ADDENDUM NO. 3

**RE: Item #1, December 10, 2025 Letting - P-PT 0011(145)83, PCN 05V6, Minnehaha County -
Structure (186' Steel Girder & 340' Steel Girder), Approach Grading & Asphalt Concrete
Surfacing**

PLANS: Please destroy sheets A2, E2, E4-E6, E11, E34 & E35 and replace with the enclosed sheets, dated 12/5/25.

STATE OF	PROJECT	SHEET NO.	TOTAL SHEETS
S.D.	P - PT 0011(145)83	E11	E59

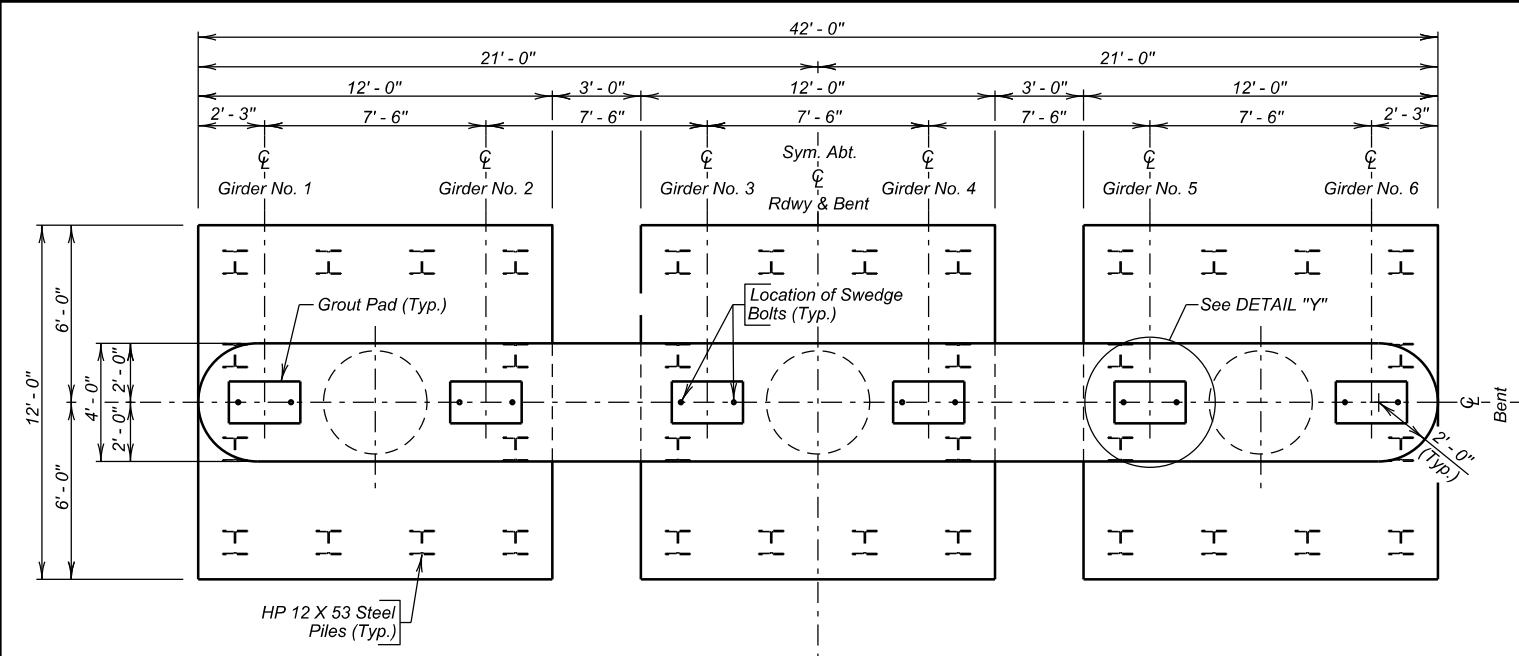
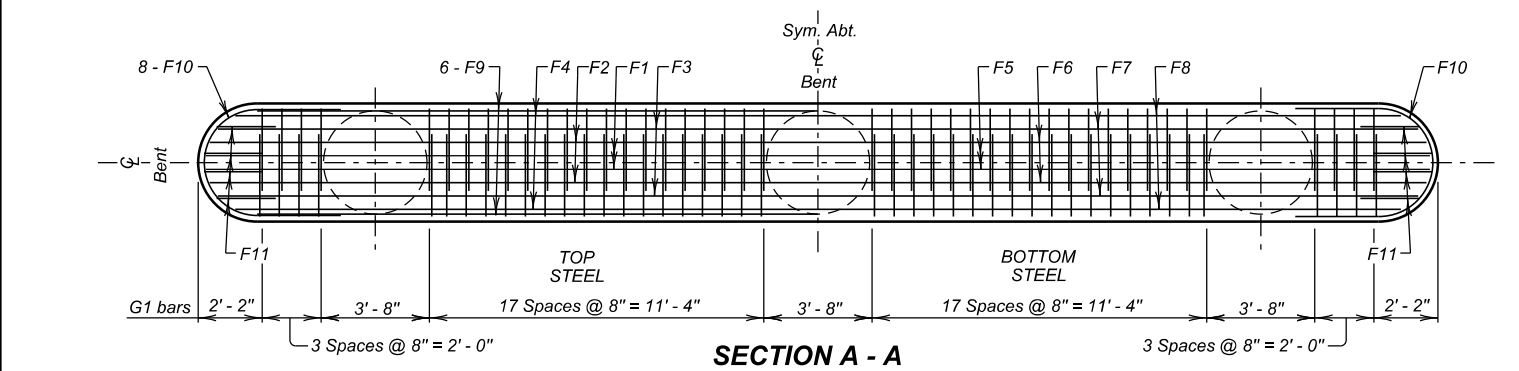
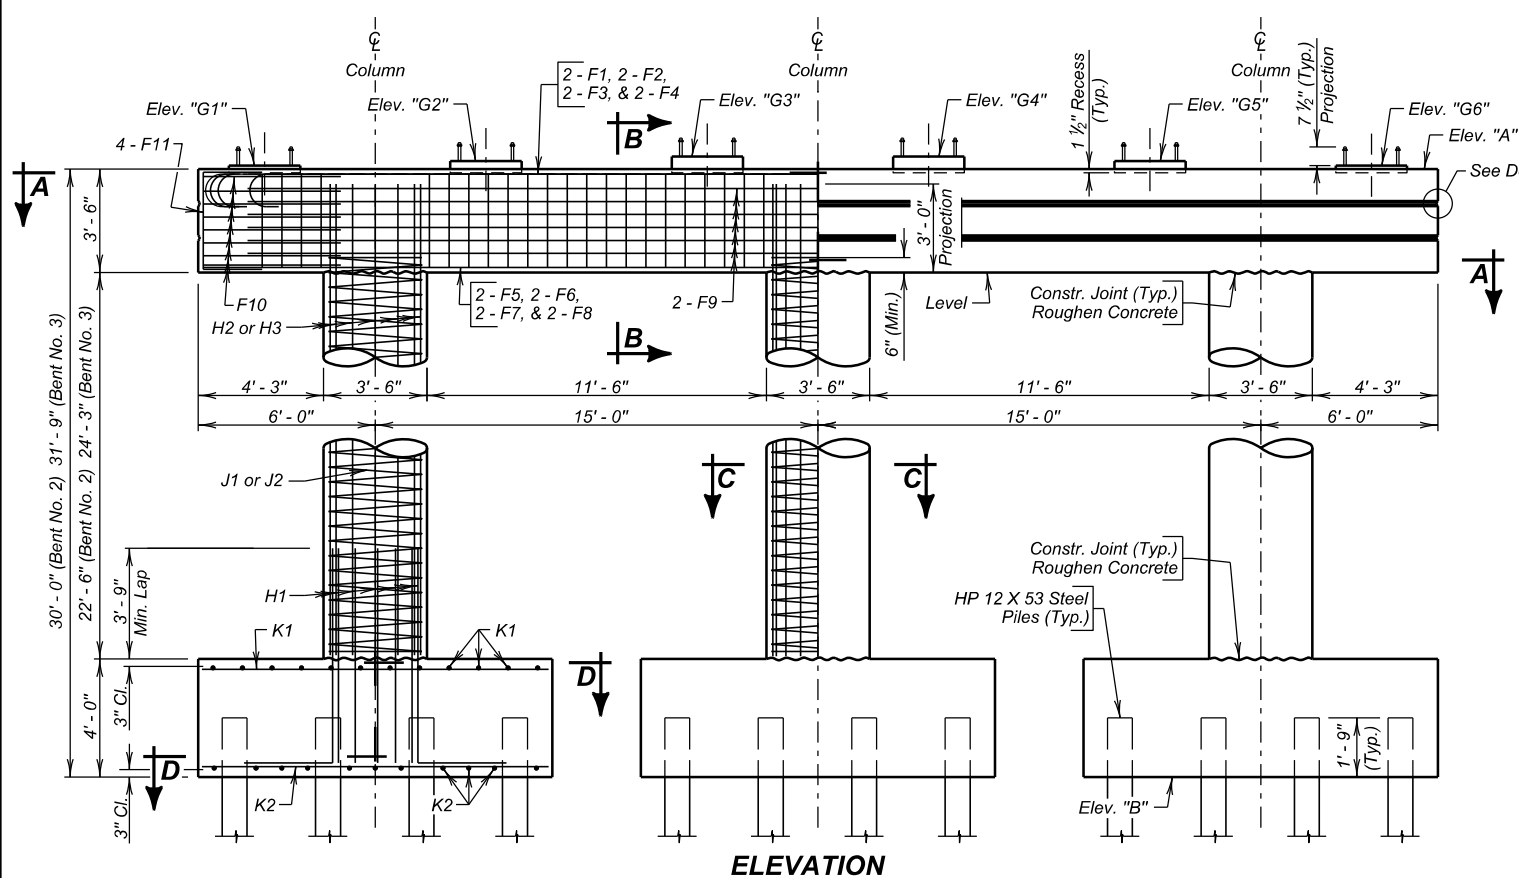
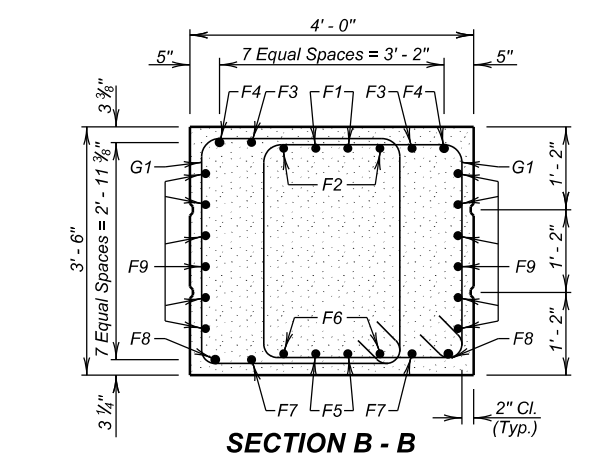
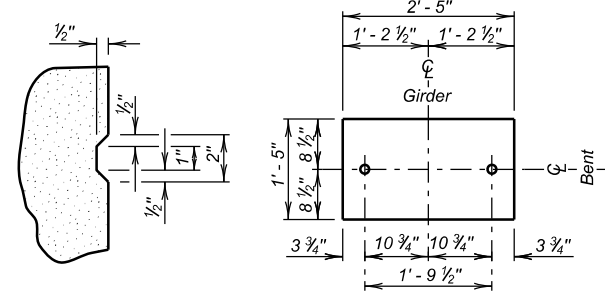
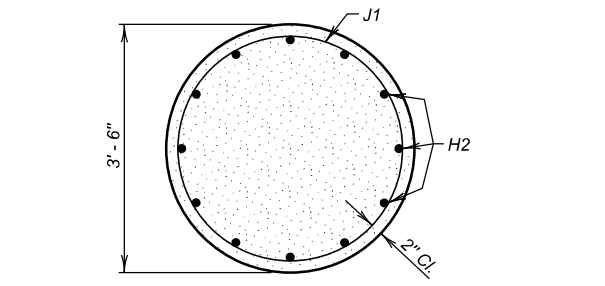
Sheet E11: ESTIMATED QUANTITIES was revised.

ESTIMATED QUANTITIES

ITEM	UNIT	QUANTITY
Class A45 Concrete, Bridge	Cu. Yd.	109.6
Reinforcing Steel	Lb.	15185
Structure Excavation, Bridge	Cu. Yd.	152
HP 12 X 53 Steel Test Pile, Furnish and Drive	Ft.	1 @ 25' = 25'
HP 12 X 53 Steel Bearing Pile, Furnish and Drive	Ft.	35 @ 25' = 875'
HP 12 Pile Tip Reinforcement	Each	36
Preboring Grouted Pile	Ft.	36 @ 5' = 180'
